UNITED STATES PATENT AND TRADEMARK OFFICE

APPLICATION NO.	FILING DATE	FIRST NAMED INVENTOR	ATTORNEY DOCKET NO.	CONFIRMATION NO.
10/009,318	05/29/2002	Heinrich Feichtinger	20496-312	6972

Office Action Summary	Application No. 10/009,318	Applicant(s) FEICHTINGER ET AL.	
	Examiner Melvyn J. Andrews	Art Unit 1742

DETAILED ACTION

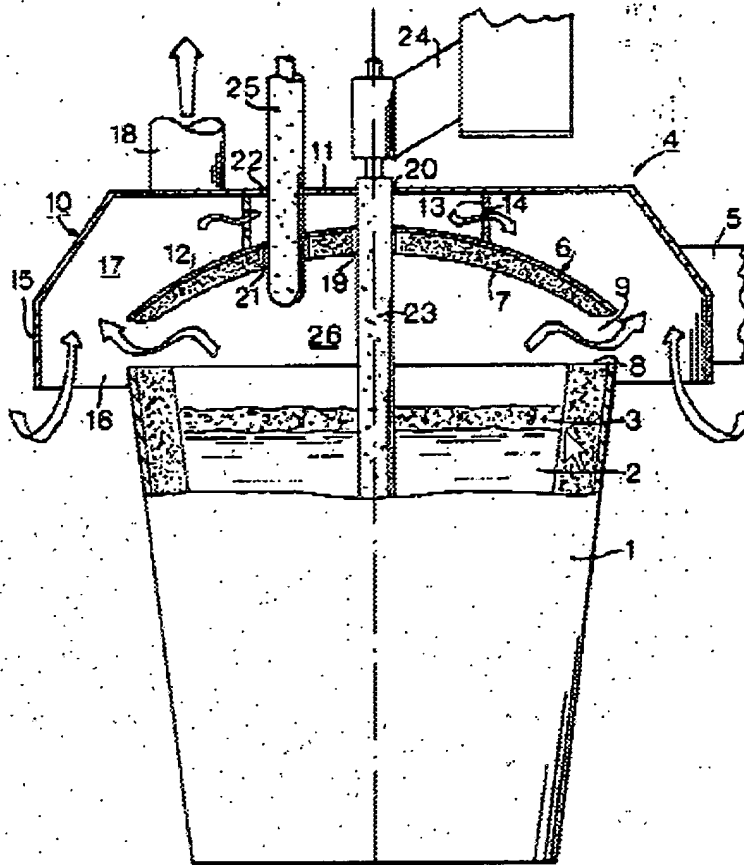
Claims 17 to 22 are rejected under 35 U.S.C. 103(a) as being unpatentable over Tivelius (US No.4,401,464). Tivelius discloses equipment for an injection metallurgy method as illustrated below:

includes a ladle 1, a hood 4 (col.4, lines 57 to 63) in which an overpressure is maintained (col.4, line 25) and into which calcium cyanide can be employed so as to simultaneously provide the steel with alloying nitrogen (col.3, lines 25 to 7), which calcium compounds may be injected (col.3, lines 34 and 35) but does not explicitly disclose the claimed metering devices, pressure sensor, temperature sensor, device for determining concentration of gases in the vessel, an evaluation unit and a control device but the Tivelius method would necessarily employ such apparatuses in order to carry out the method which includes steps such as purging the melt with an inert gas , injecting a calcium compound such as calcium cyanide, maintaining an inert gas

overpressure (see Claim 3), taking a melt sample and analyzing for sulfur content and thereafter refining the melt (see Claim 1) all of which steps require equipment to carry out the method it would have been obvious to one of ordinary skill in the art at the time the invention was made to provide the equipment needed to carry out the Tivelius method since nitrogen alloying is being carried out in both cases.
